BCA FIRE SAFETY UPGRADE STRATEGY REPORT

Building Address	157 Ocean Street, Narrabeen
Report No.	3580
Report For	Strata Plan 3128 (157 Ocean Street Narrabeen)
Report By	Greg Murrow
Title / Company	Director Murrow Consulting Pty Ltd
Date	27 May 2024

This report provides a Building Code of Australia (BCA) fire safety upgrade strategy for the existing four (4) storey residential apartment building at 157 Ocean Street, Narrabeen, NSW.

ANNEXURE 3 – SYDNEY WATER STREET HYDRANT DIAGRAM

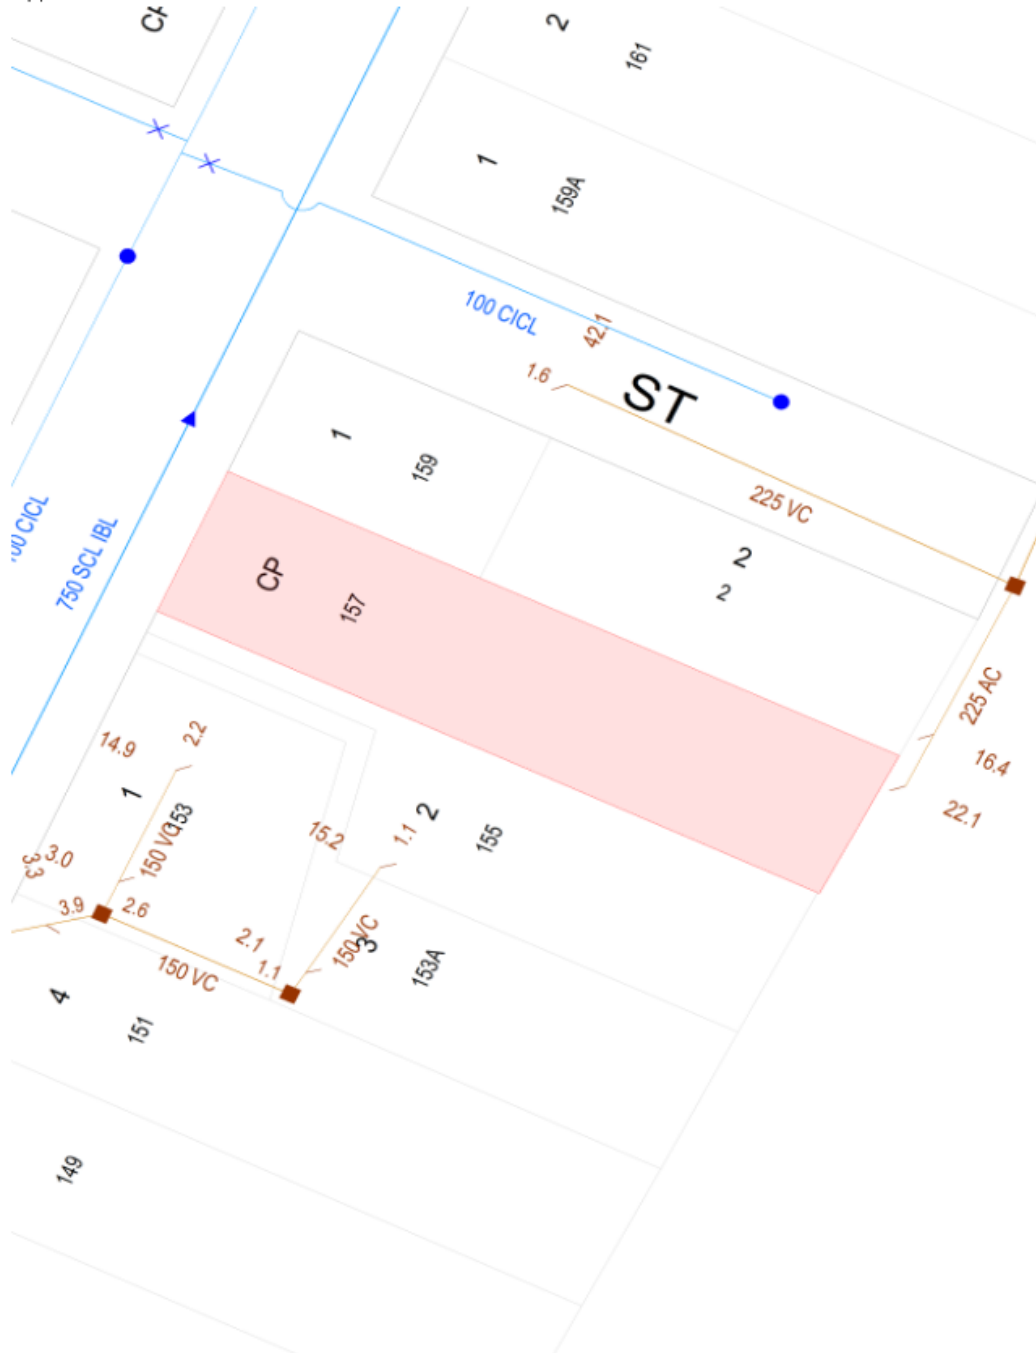
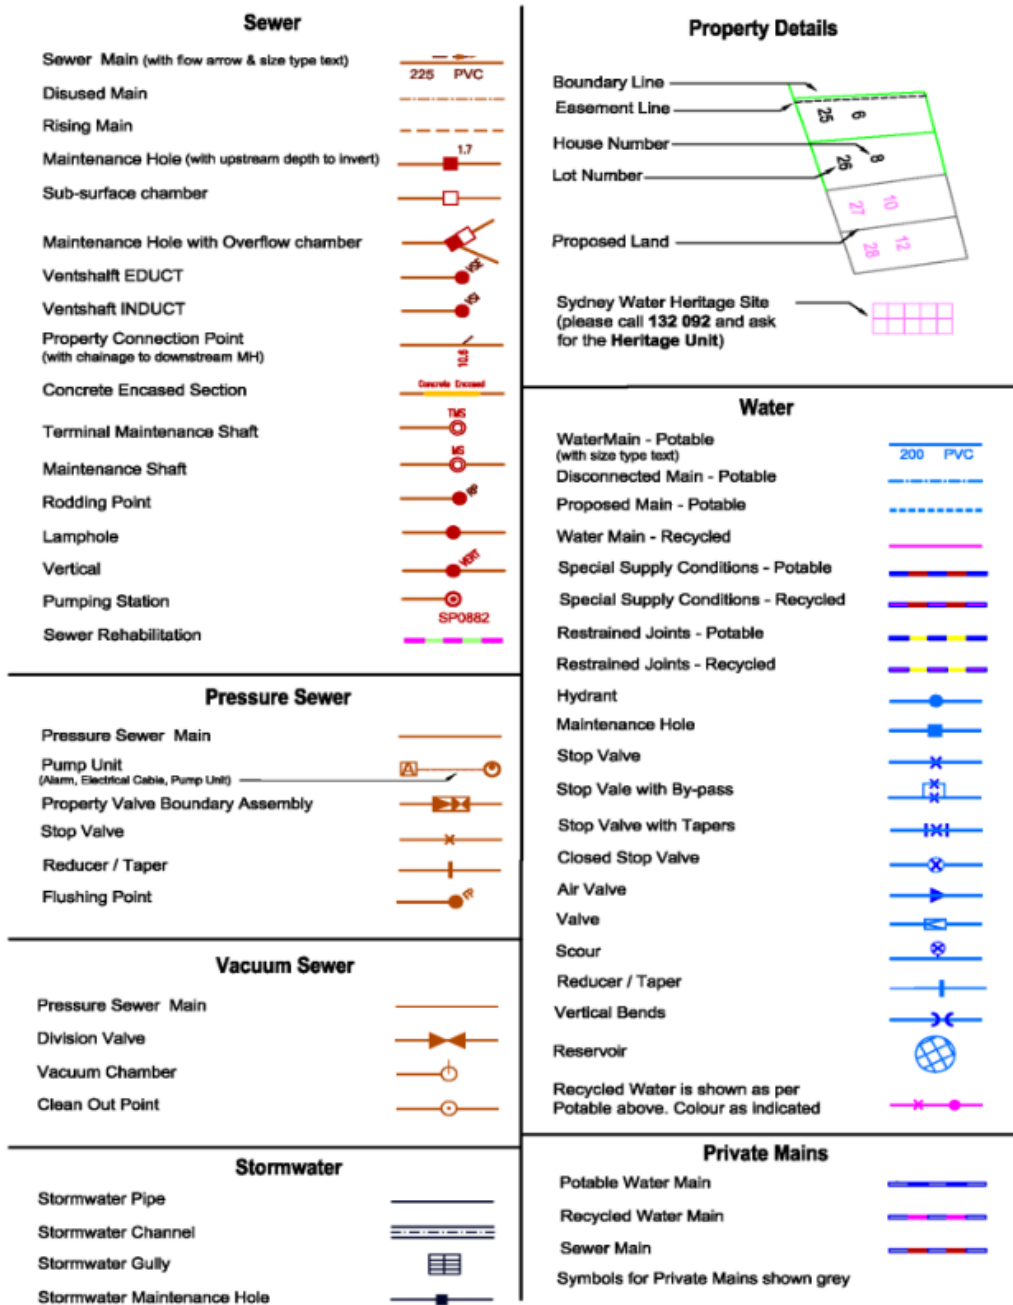
12.	<p><u>E1D2 – Adequacy of street hydrant</u></p> <p>The building is only served by a street hydrant in the footpath in front of 156 Ocean Street (at the corner of Octavia Street) (see Annexure 3) which may not meet the pressures and flows requirements of AS 2419.1-2021 and does not meet the coverage requirements of AS 2419.1-2021 as not all parts of the building are not more than 70m from a fire brigade pumping appliance located on a hardstand within 20m of the street hydrant, as measured in accordance with Figure H.6.2 of AS 2419.1-2021 (see below diagram).</p>	<p><u>Option 1</u></p> <p><u>Pressures and flows from subject street hydrant</u></p> <p>Obtain information from Sydney Water confirming the available pressures and flows from the street hydrant in the footpath in front of 156 Ocean Street (at the corner of Octavia Street) meets the pressures and flows requirements of AS 2419.1-2021.</p> <p><u>Coverage from subject street hydrant</u></p> <p>As coverage from the street hydrant exceeds that measured in accordance with Figure H.6.2 of AS 2419.1-2021, a concession shall be sought and obtained from Fire + Rescue NSW in accordance with their “<i>Fire hydrant concessions for existing buildings Technical Information Fire Safety Guideline</i>” (Ref: D16/62522, Version 01, dated 27.02.20 – see below link). https://www.fire.nsw.gov.au/gallery/files/pdf/guidesheets/Tech%20info%20sheet%20-%20Existing%20buildings-Fire%20hydrant%20concession.pdf</p> <p><u>Option 2</u></p> <p>As coverage from the street hydrant in the footpath in front of 156 Ocean Street (at the corner of Octavia Street) exceeds that measured in</p>

Item No.	DTS non-compliance against BCA 2022	Recommended BCA Fire Safety Upgrade Works	Photographs
		<p>accordance with Figure H.6.2 of AS 2419.1-2021, a new on-site hydrant system will be required to be installed in accordance with BCA Clause E1D2 and AS 2419.1-2021.</p>	<p>Figure H.6.2 — Street fire hydrant coverage</p>
